ZAYO'S PRINEVILLE TO RENO PROJECT

CPUC MINOR PROJECT REFINEMENT FORM

Date Requested: 15 Oct 2024 submitted to CPUC on October 21, 2024	Report No.: 5
Date Approved: 10/25/2024	Approval Agency: Caltrans, in addition to CPUC
Property Owner(s): Caltrans (State Route 395 ROW)	Location/Milepost: PM M-29.7 to M-32.5 (S to N)
Land Use/Vegetative Cover: Ruderal (maintained highway shoulder near edge of pavement)	Sensitive Resources: Waterways at culverts to be avoided by boring underneath culverts. Cultural resources will still need to be avoided. (See project webmap.)

SHEET NO.: 61 OF 94

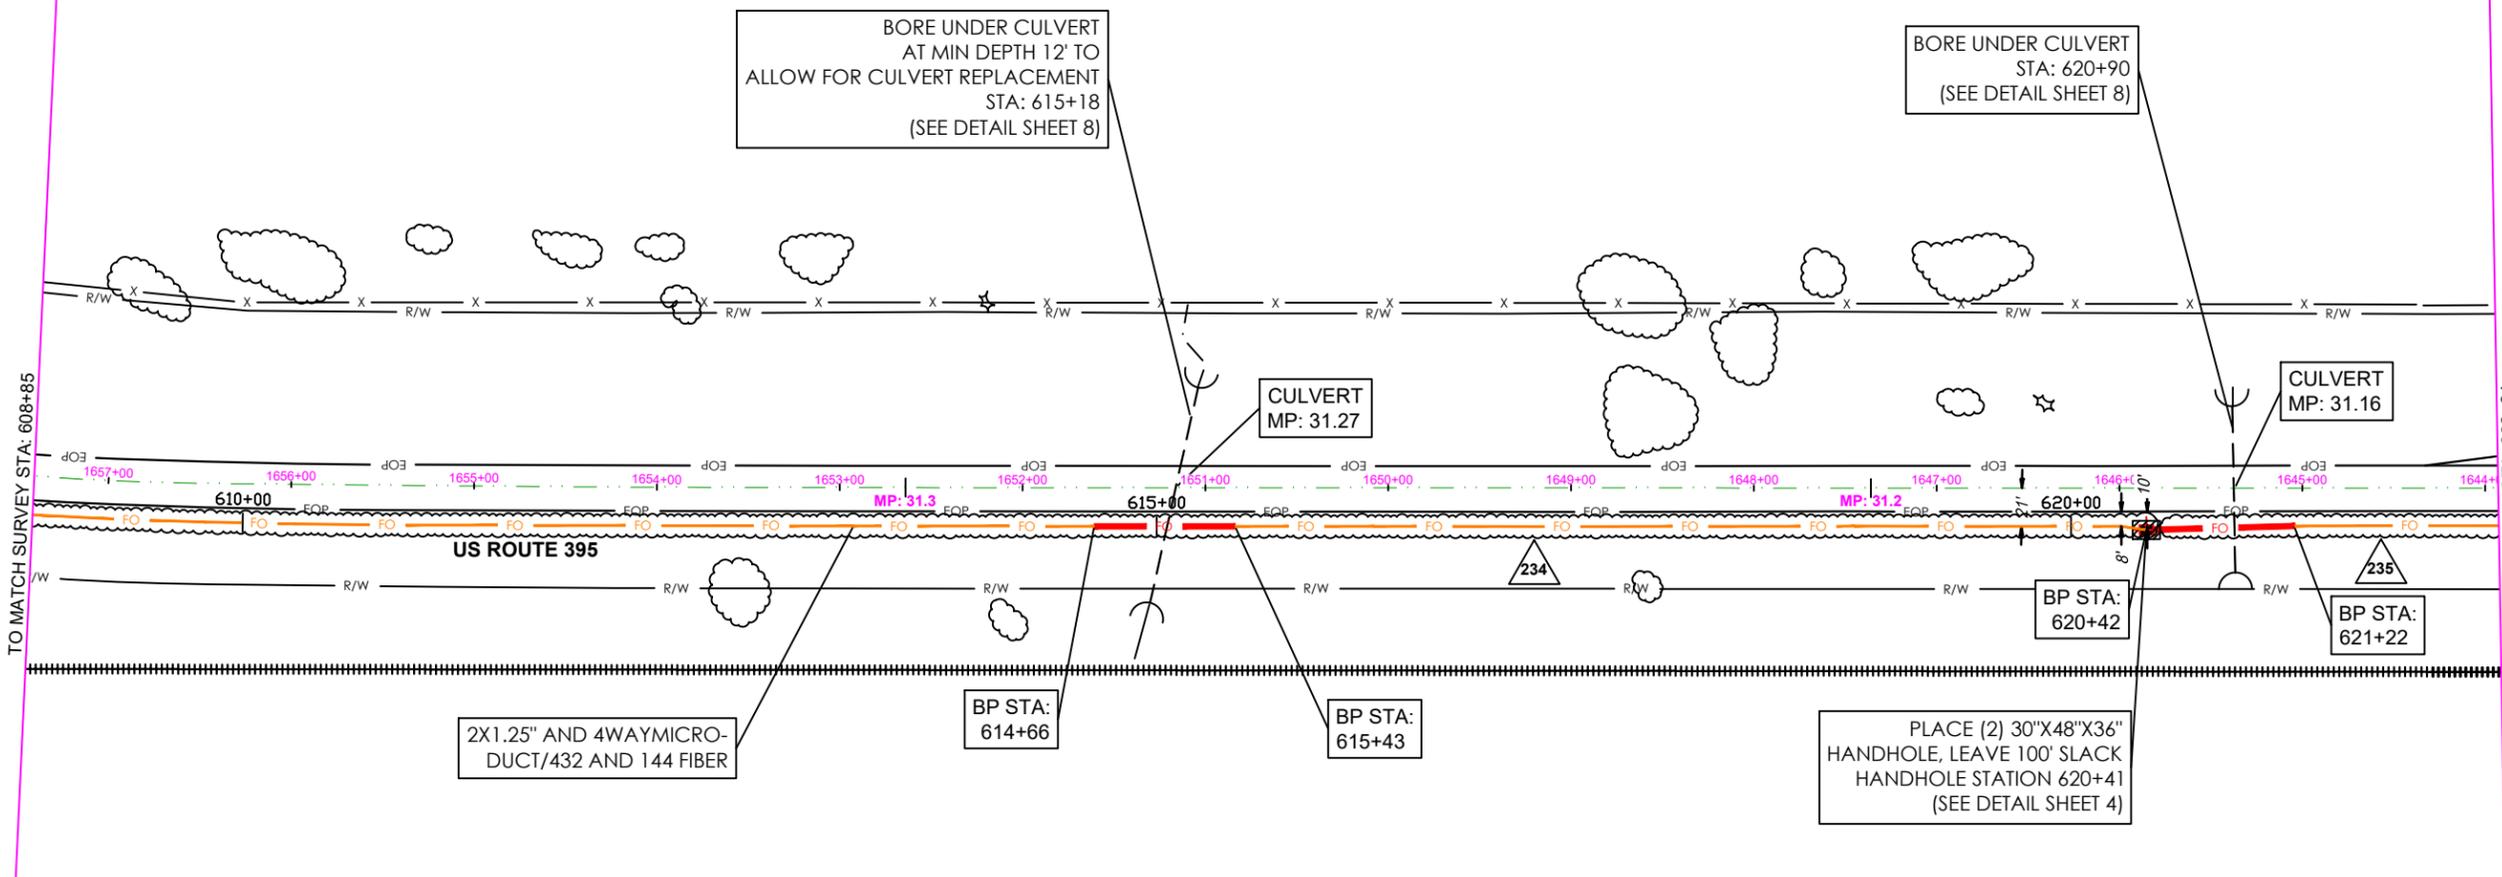
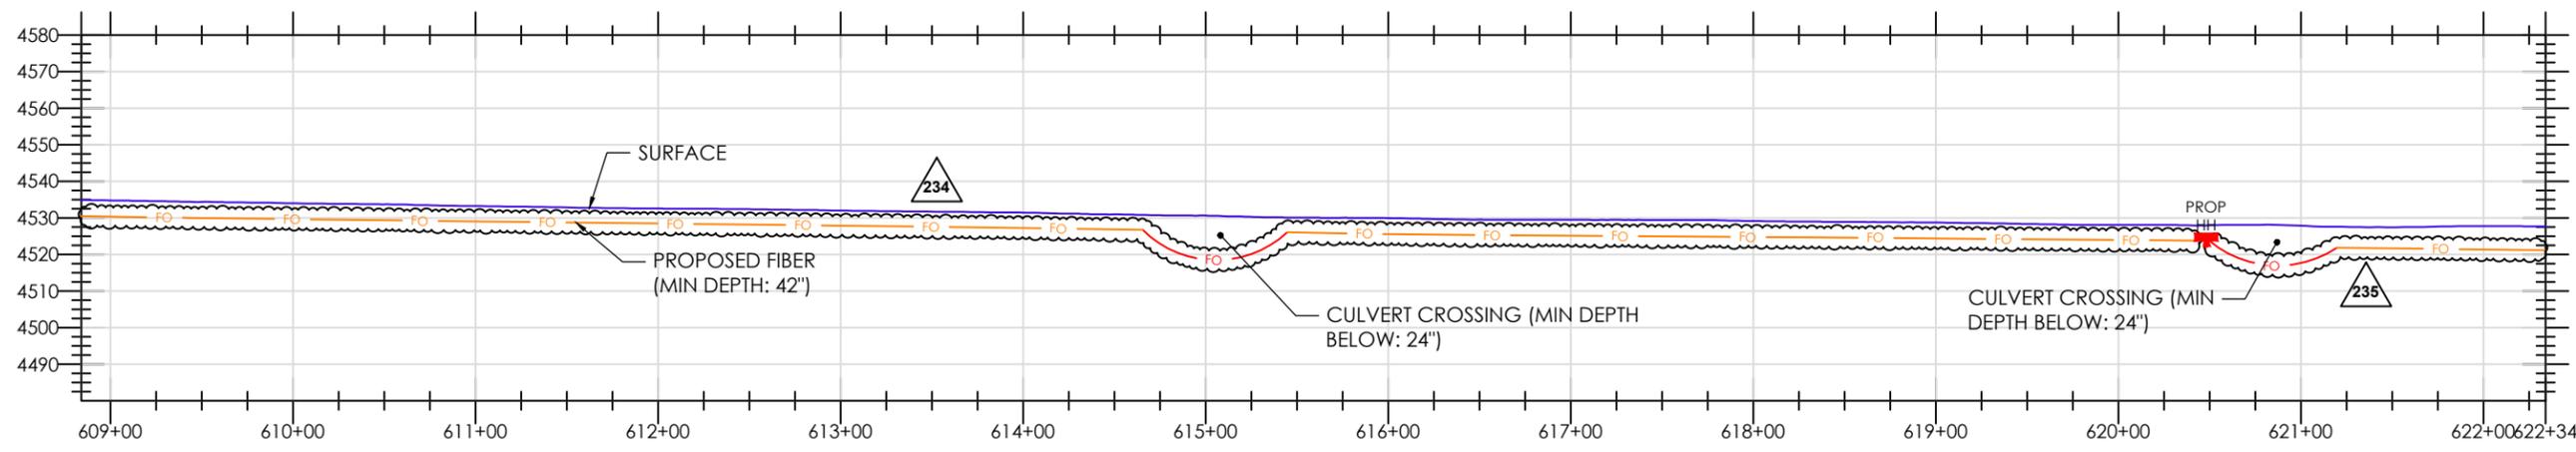
RFI NO. 0234
SHIFT ALIGNMENT TO WEST SIDE
8 FEET FROM EOP
EOP STA 550+00 TO STA 619+90
09/30/2024

RFI NO. 0235
KEEP R/L ON WEST SIDE
8 FEET FROM EOP
STA 619+90 TO STA 701+17
09/30/2024

TO MATCH SURVEY STA: 608+85

TO MATCH SURVEY STA: 622+34

SHEET NO.: 62 OF 94

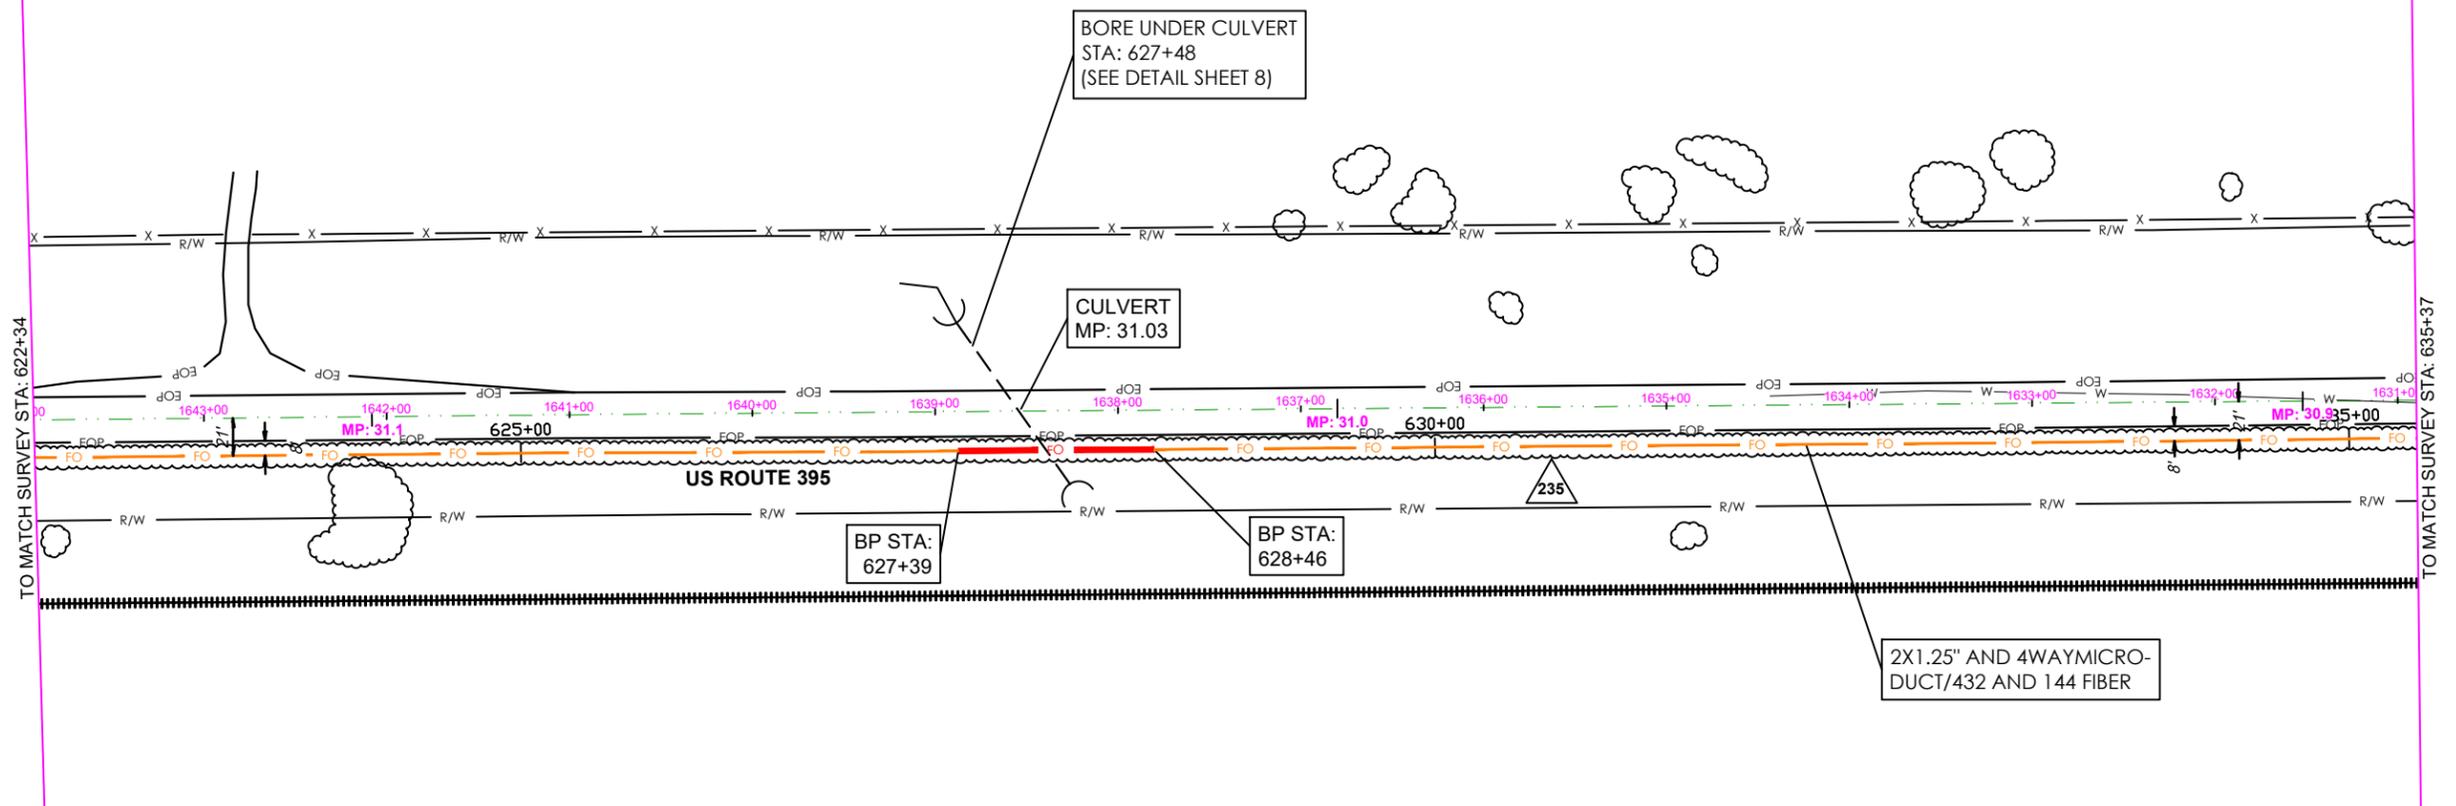
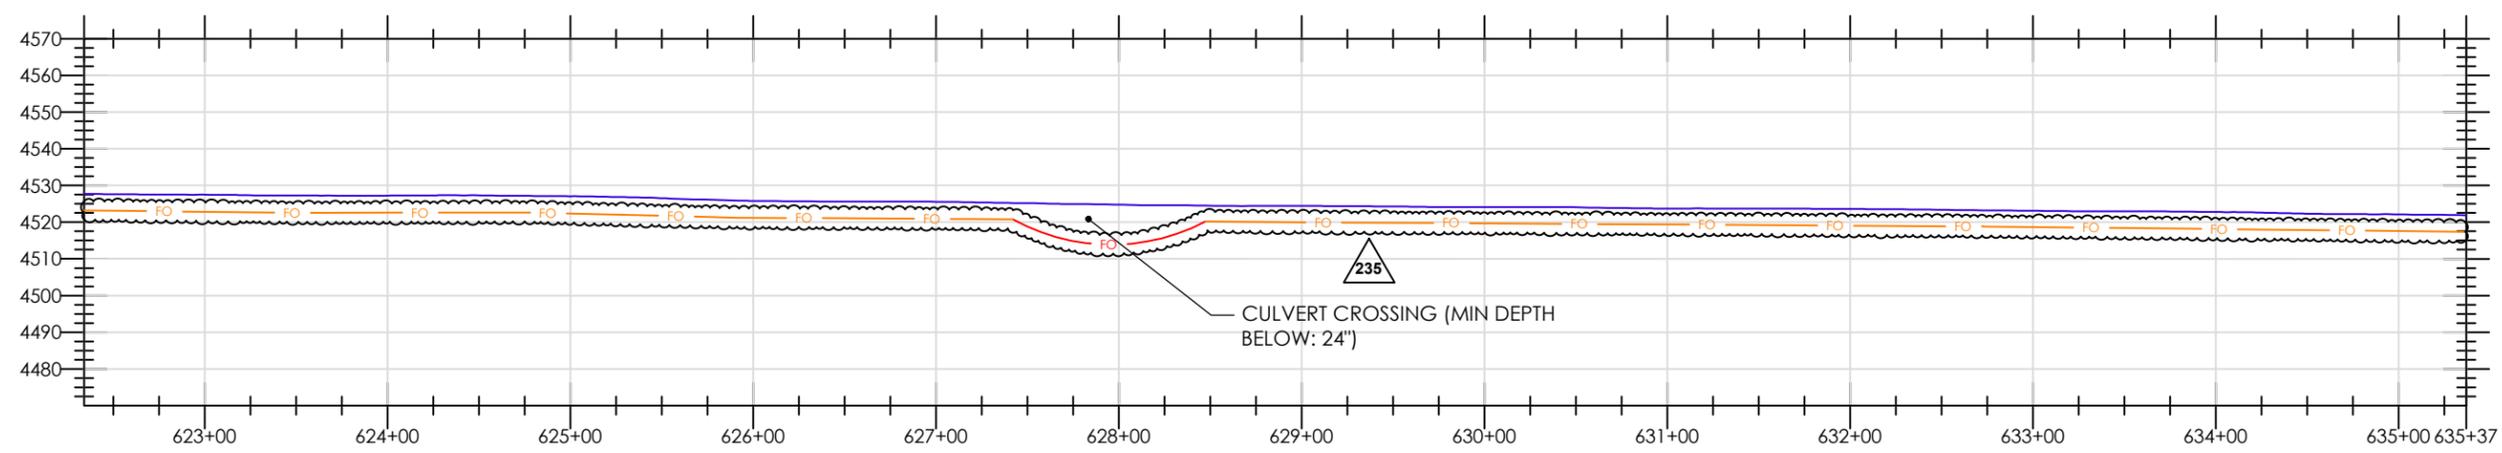
RFI NO. 0235
KEEP R/L ON WEST SIDE
8 FEET FROM EOP
STA 619+90 TO STA 701+17

SHEET NO.: 63 OF 94

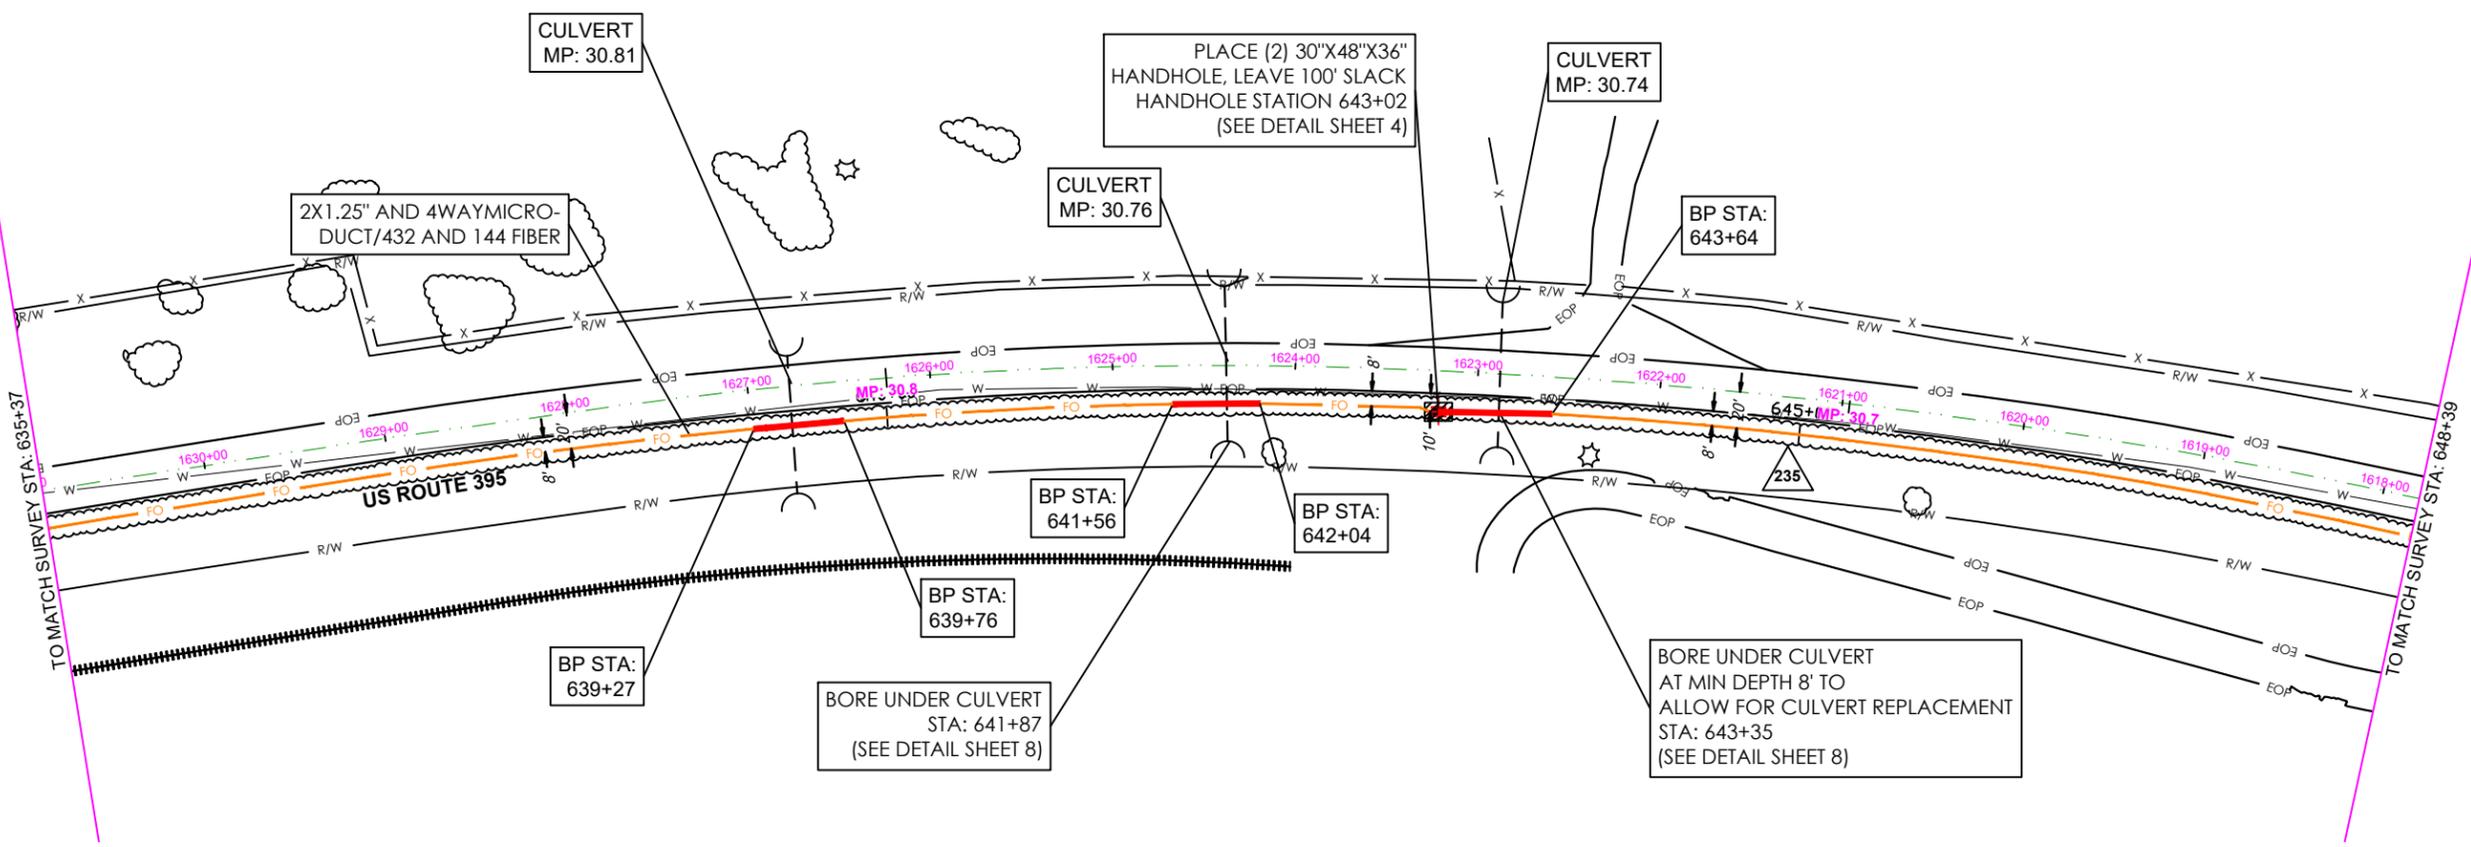
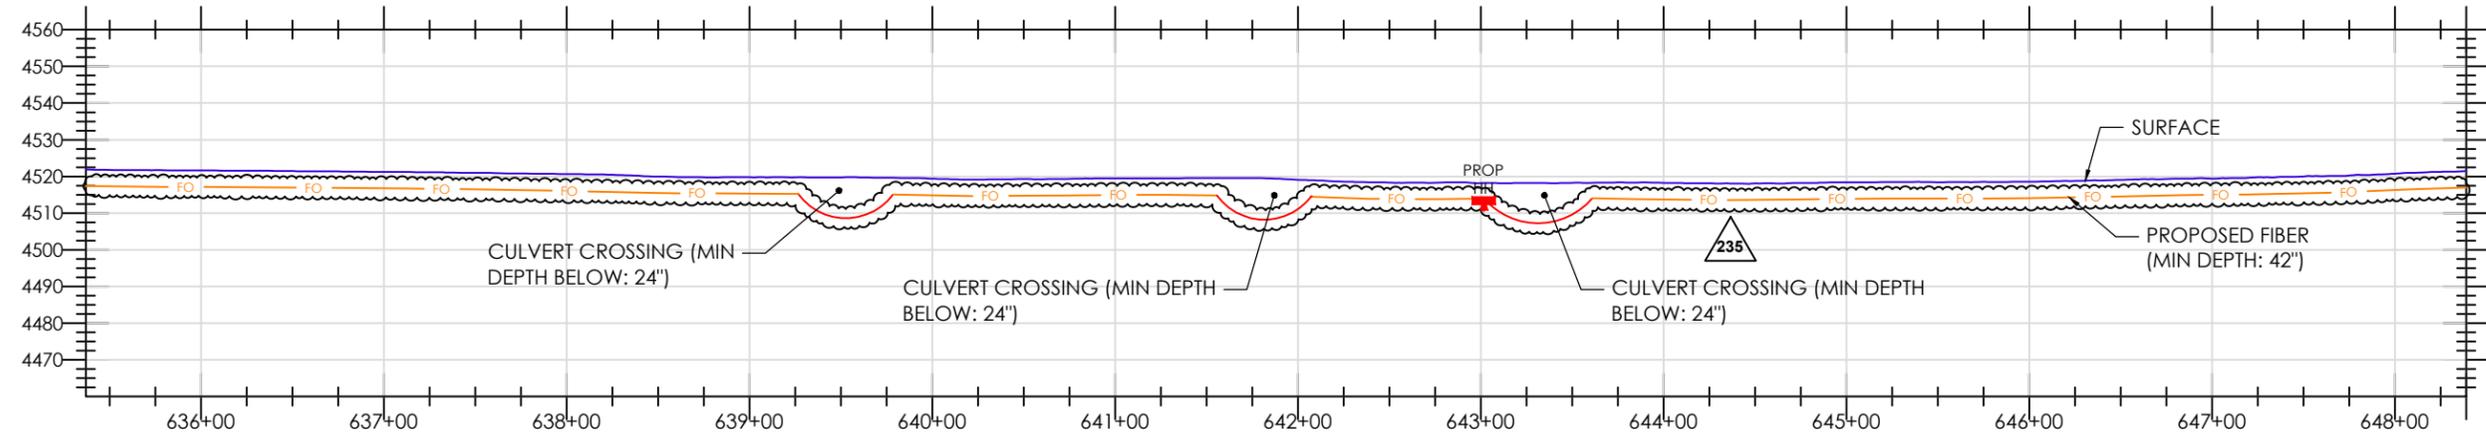
RFI NO. 0235
KEEP R/L ON WEST SIDE
8 FEET FROM EOP
STA 619+90 TO STA 701+17
